Subject: Minutes for 51st Protection Sub-Committee Meeting.

51st Protection Sub-Committee Meeting (23rd July, 2024)-MoM

**Minutes of
51st Meeting of Protection Sub-Committee (PSC) of
Northern Regional Power Committee**

DR of 220 KV Hissar(BB)-Hissar IA(HV)(end) (BBMB) Ckt-2 (11:16hrs)

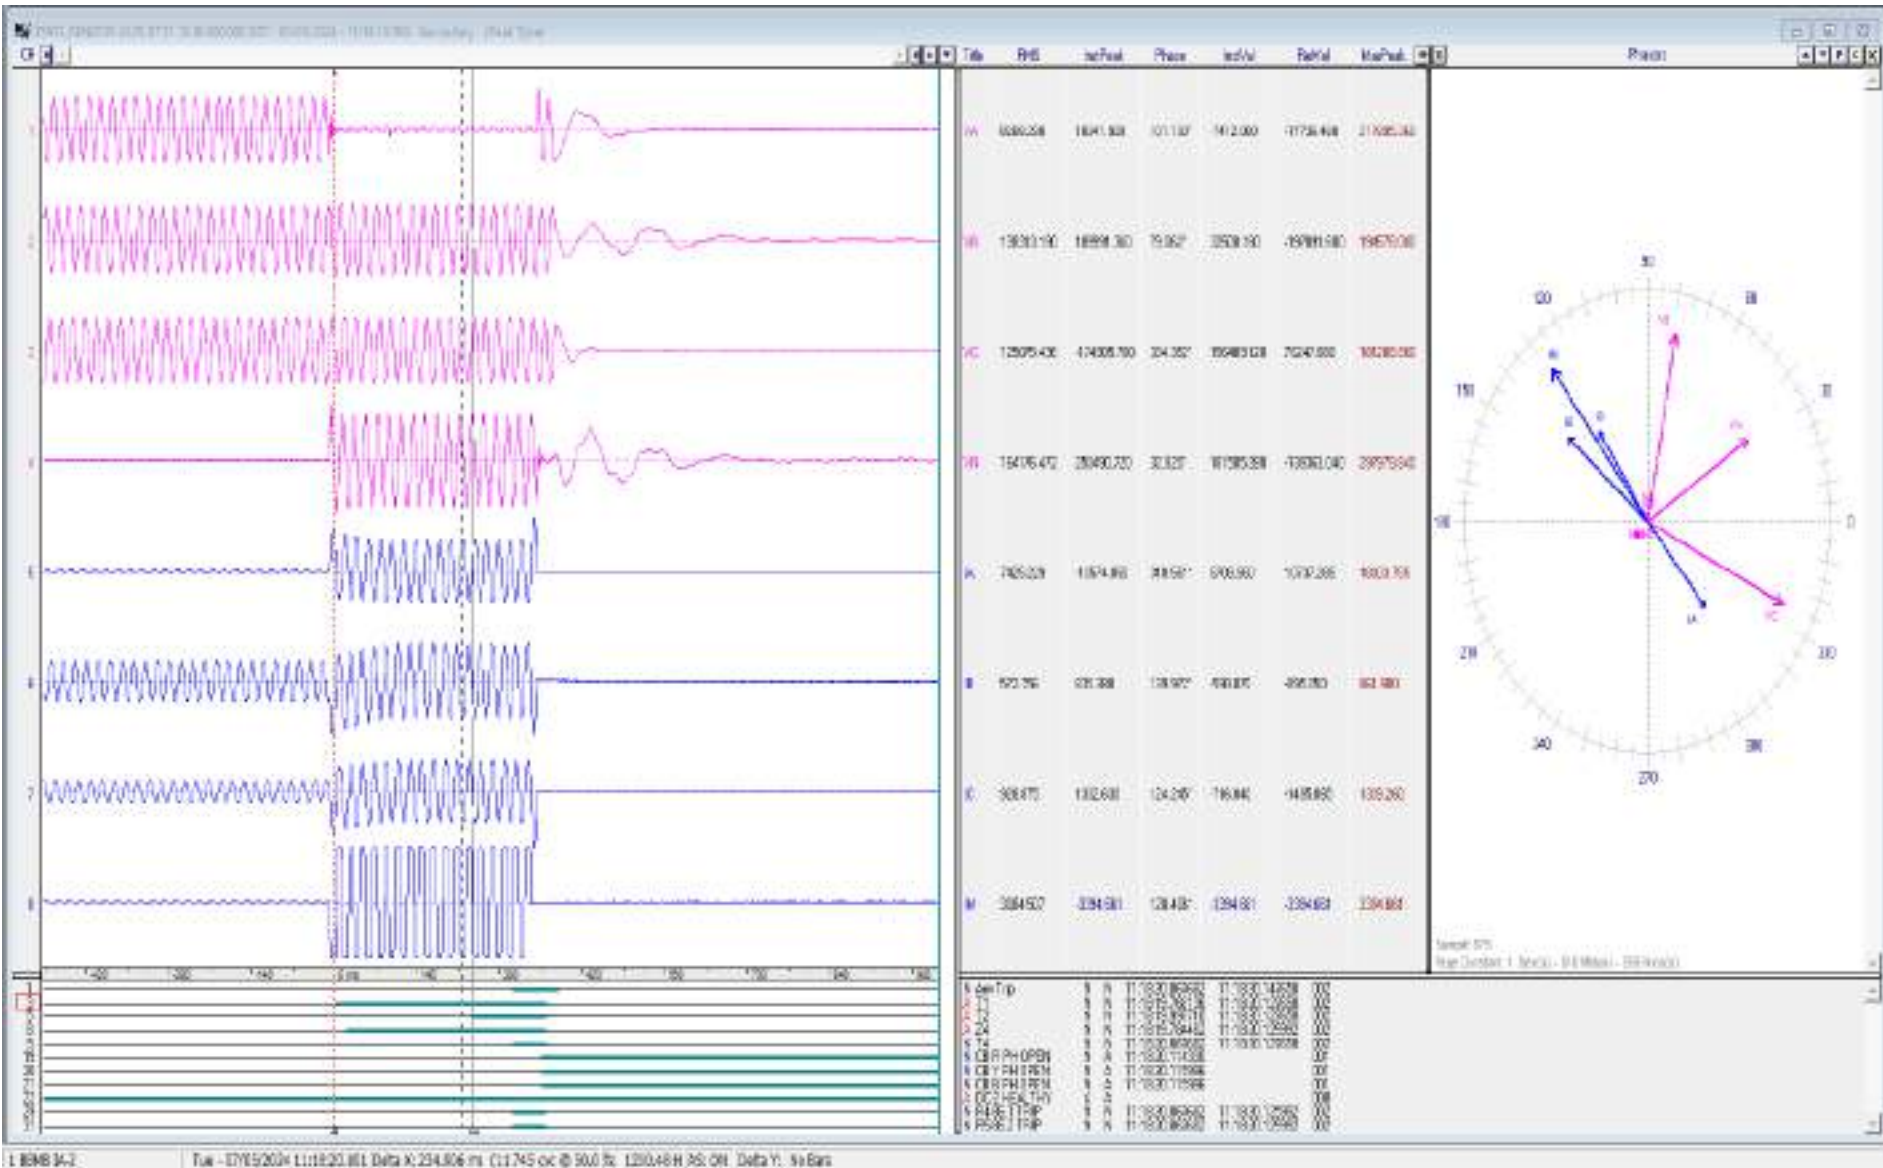
R-N phase to earth fault. Ir~7.4kA. Fault clearing time=360ms. Fault sensed in zone-4.

DR of 400 KV Akal-Barmer(end) (RS) Ckt

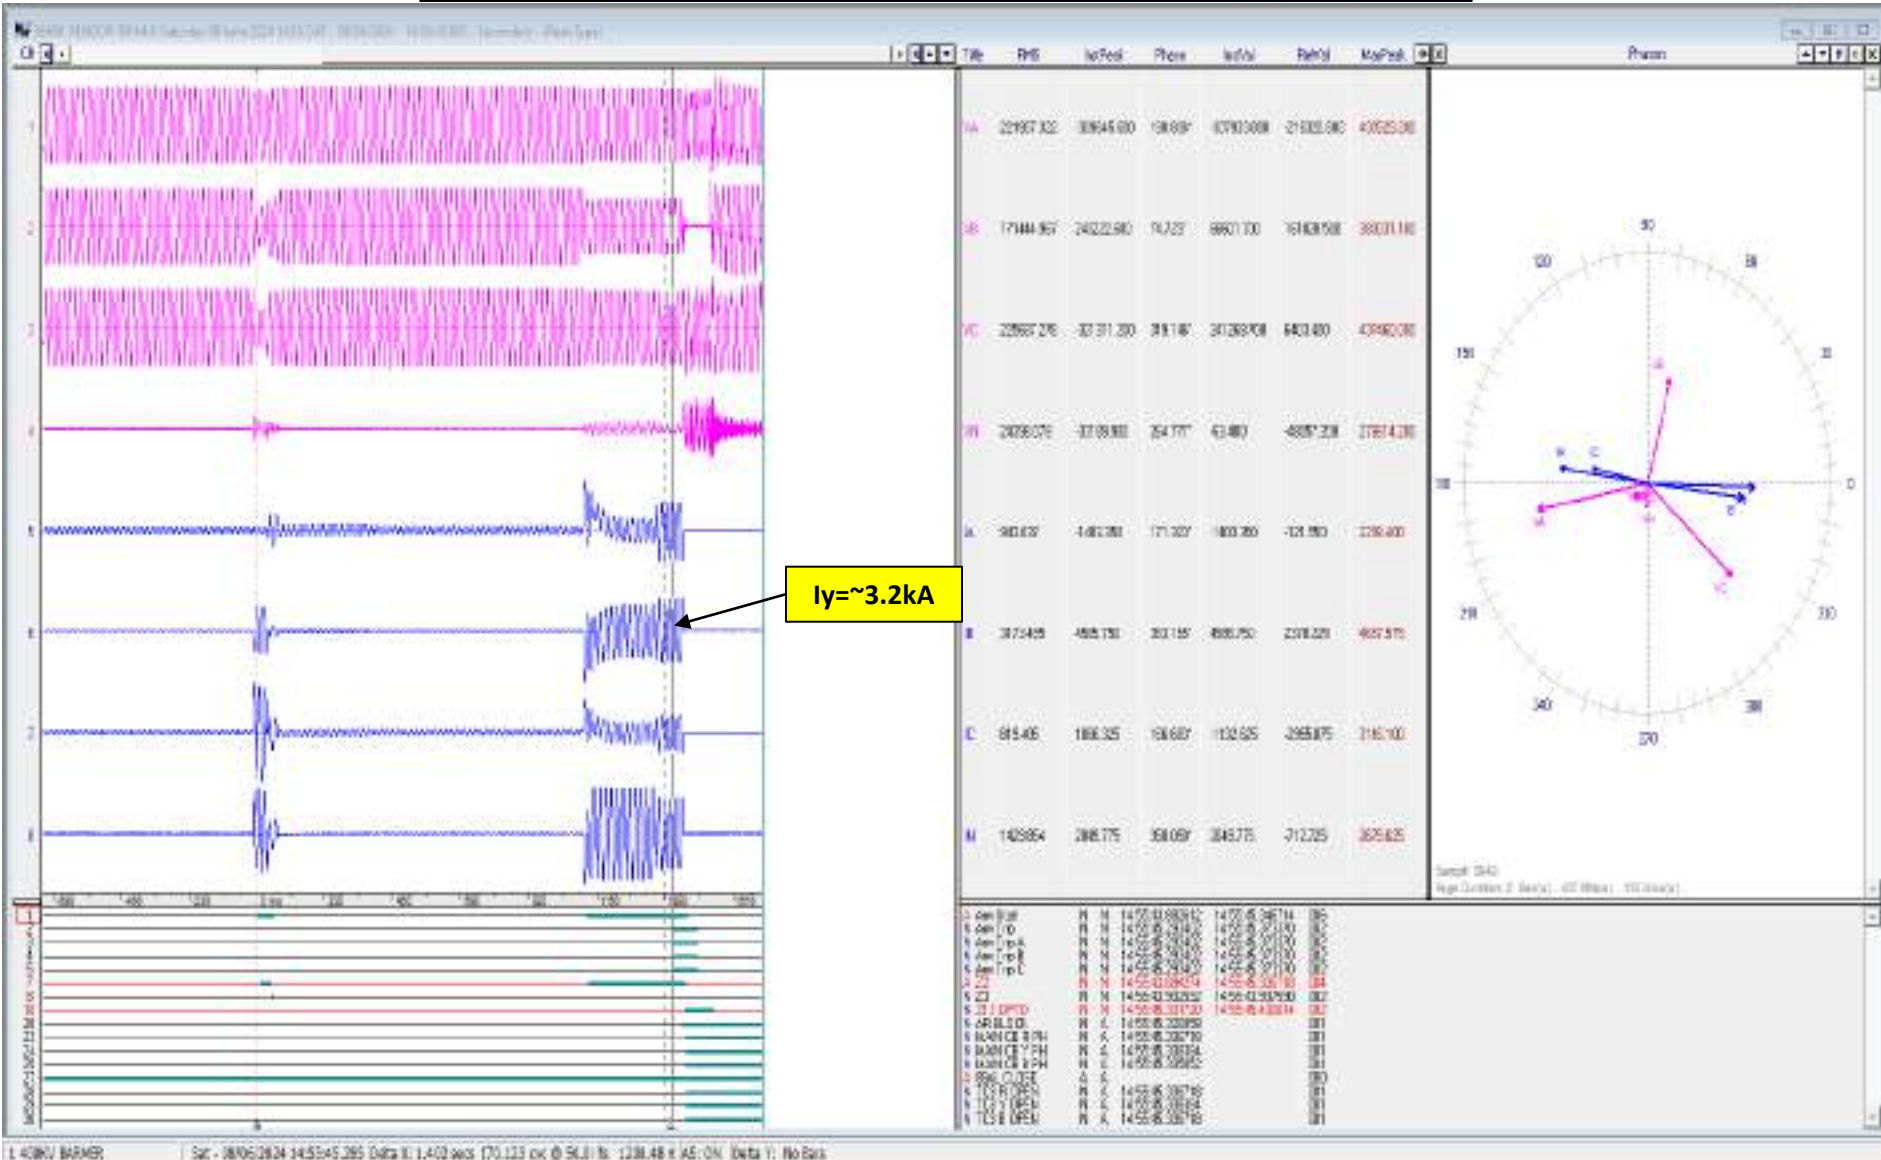
- ✓ Y-B-N double phase to earth fault ($I_y \sim 2.4\text{kA}$, $I_b \sim 2.1\text{kA}$) followed by Y-N fault ($I_y \sim 3.2\text{kA}$).
- ✓ Fault sensed in zone-2. Distance protection operated.
- ✓ Time Sync issue in DR.

DR of 400 KV Parbati 3(NH) (end)-Sainj(HP) (PKTCL) Ckt

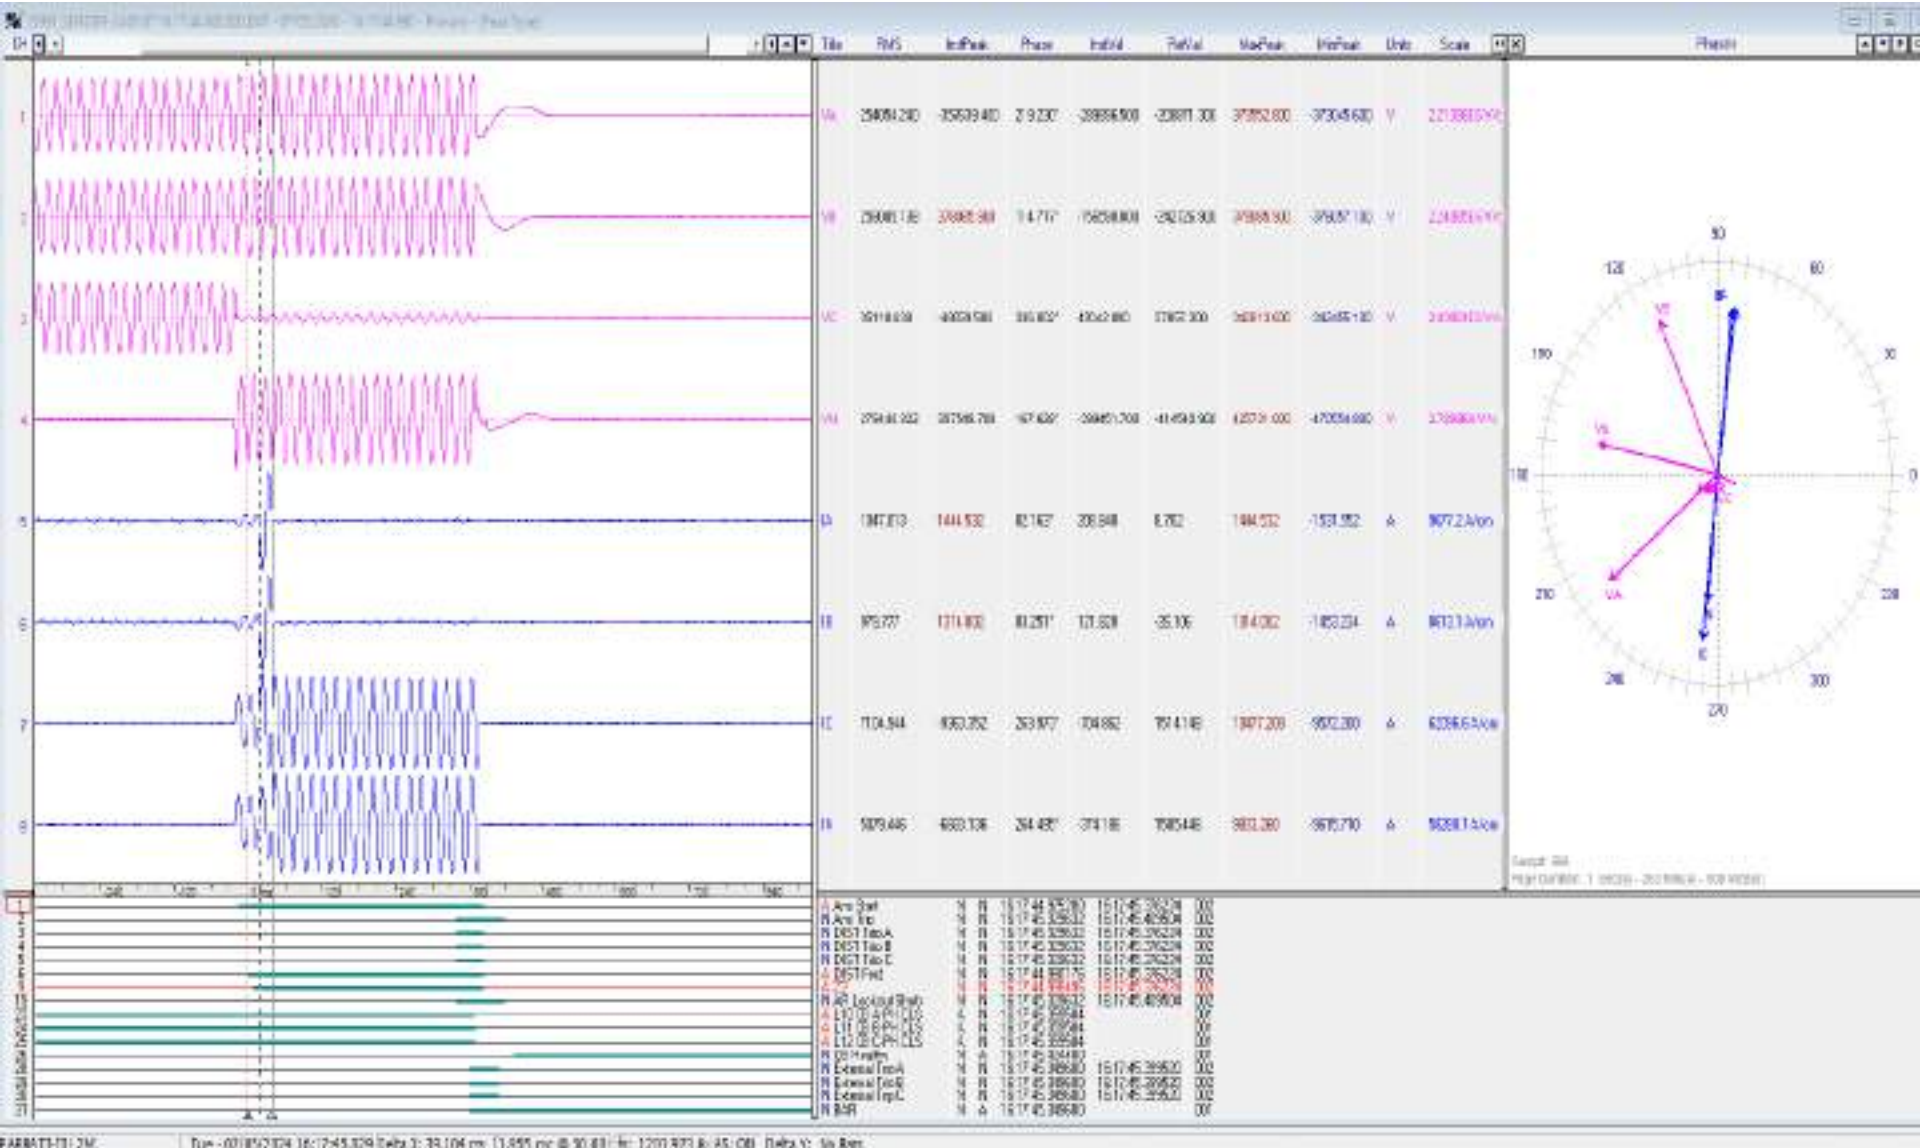
- ✓ B-N phase to earth fault; $I_b \approx 7.105 \text{ kA}$; fault sensed in zone-2 from Parbati_3(NH)
- ✓ Fault clearing time $\approx 400 \text{ ms}$

DR of 400kV Khedar-Kirori(HR) ckt-2 of Khedar end (19:08:42hrs)

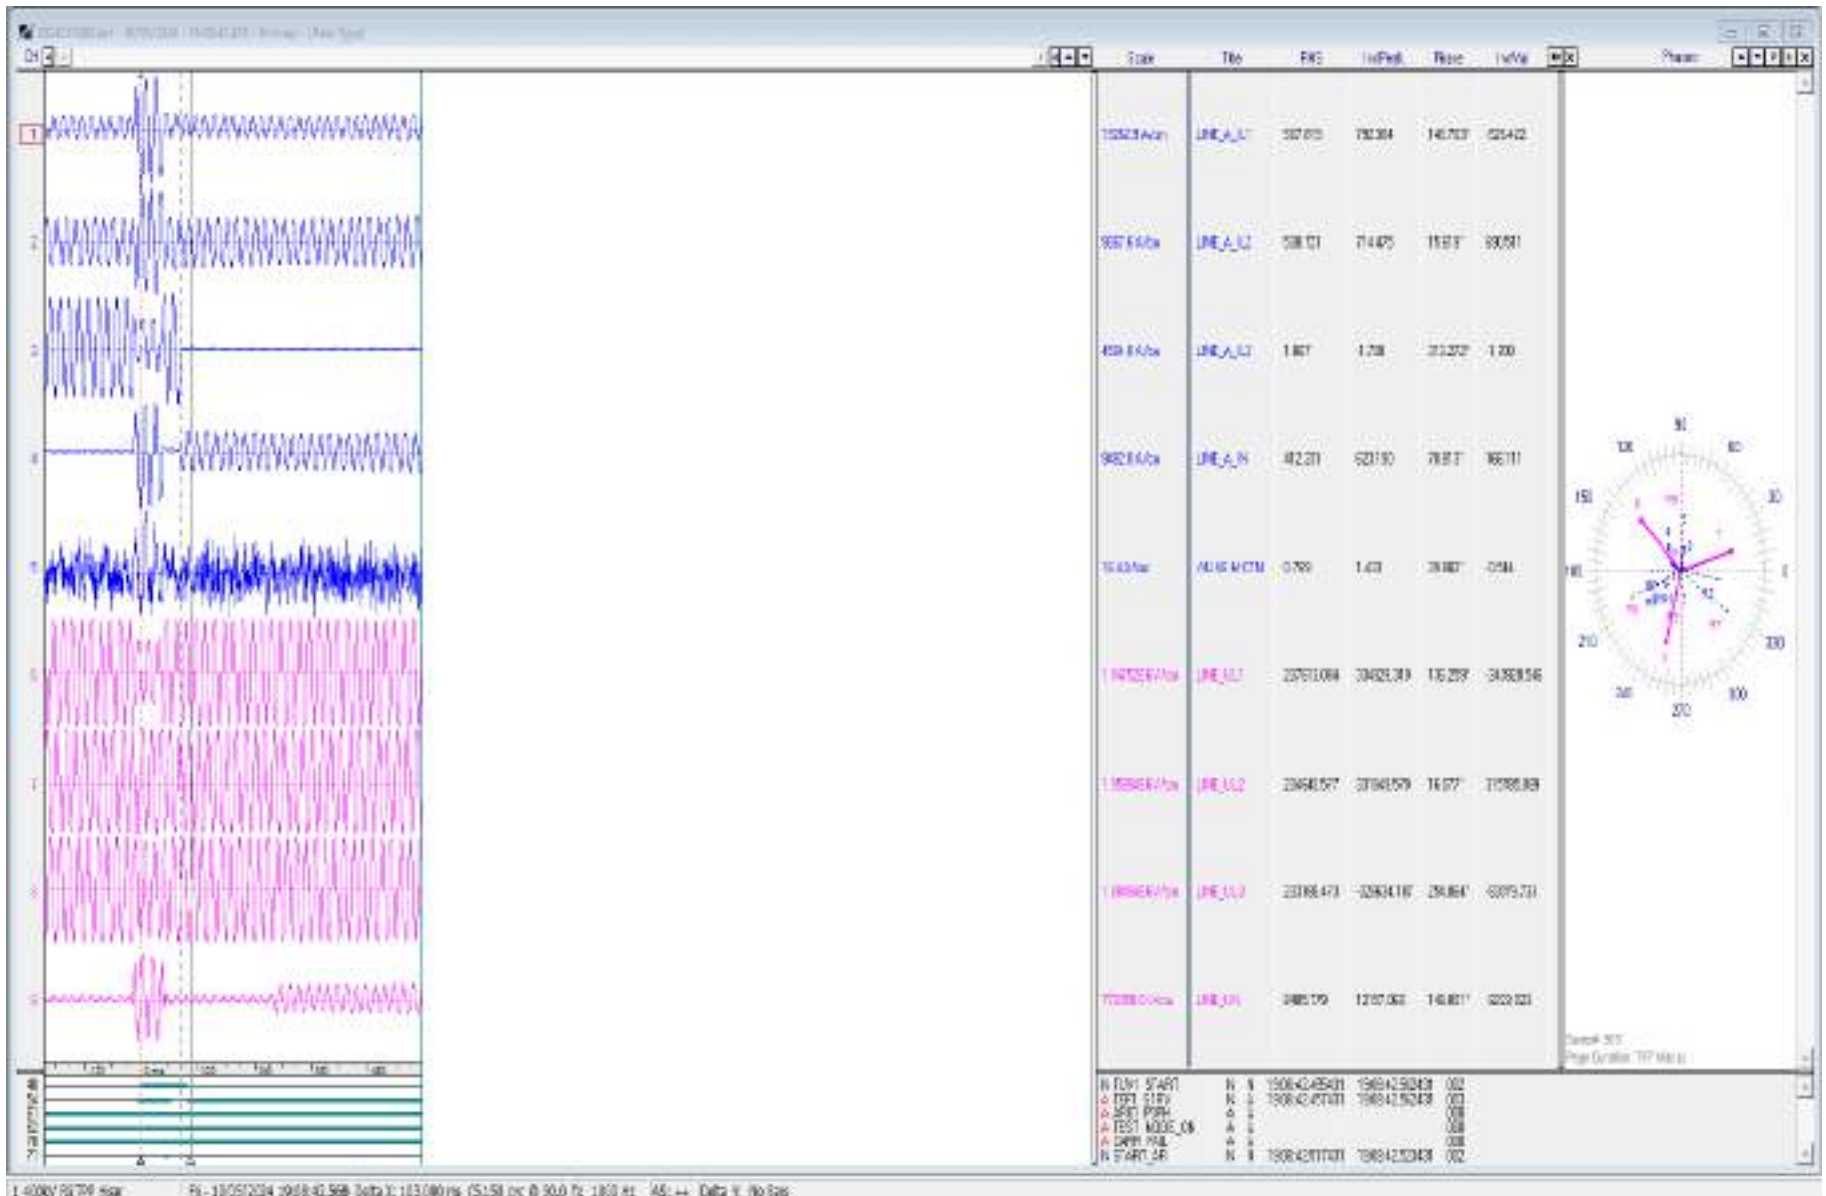
B-ph pole opened, reason of A/R start not identified

DR of 400/220 kV 500 MVA ICT 1 at Mandaula(PG)

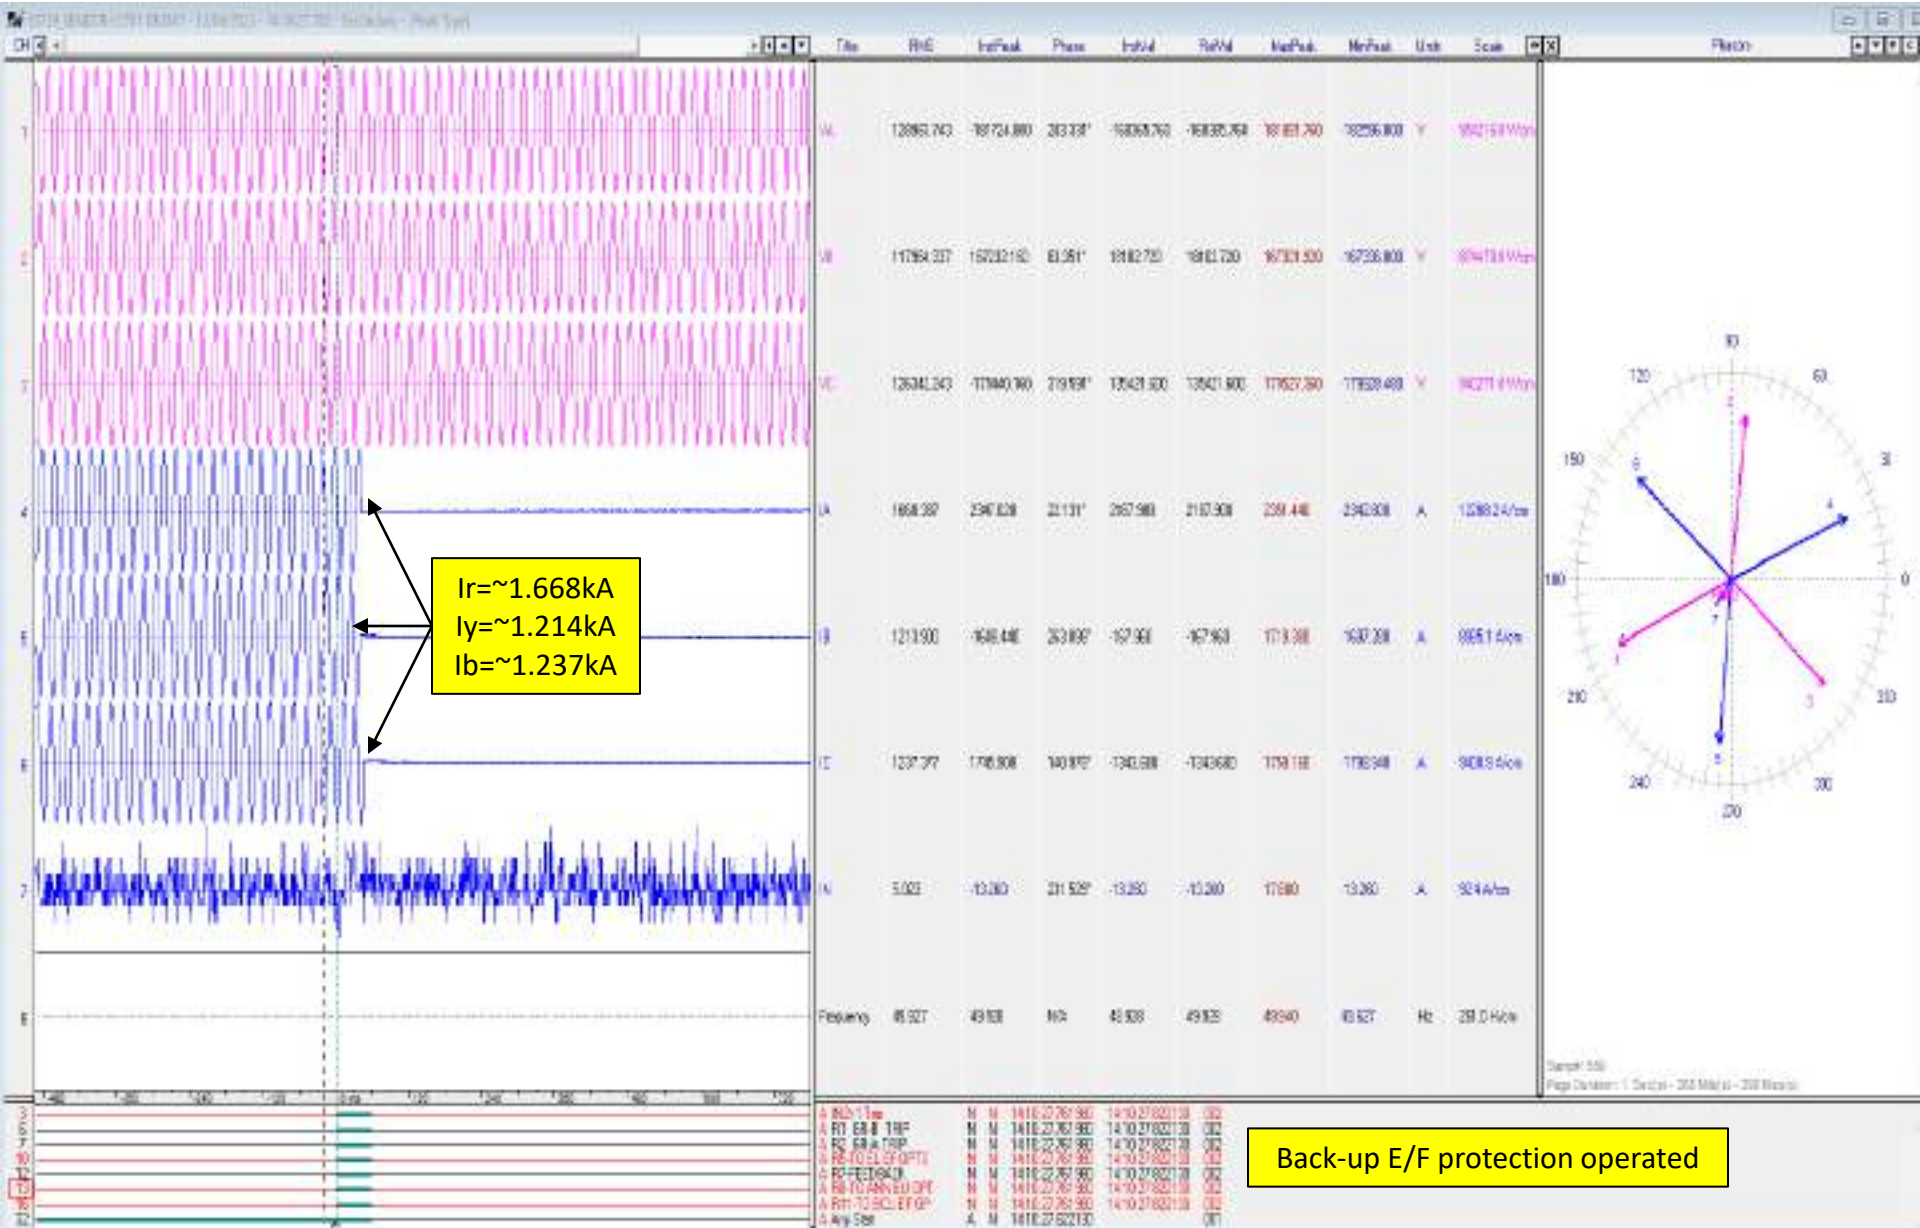
Back-up E/F protection operated
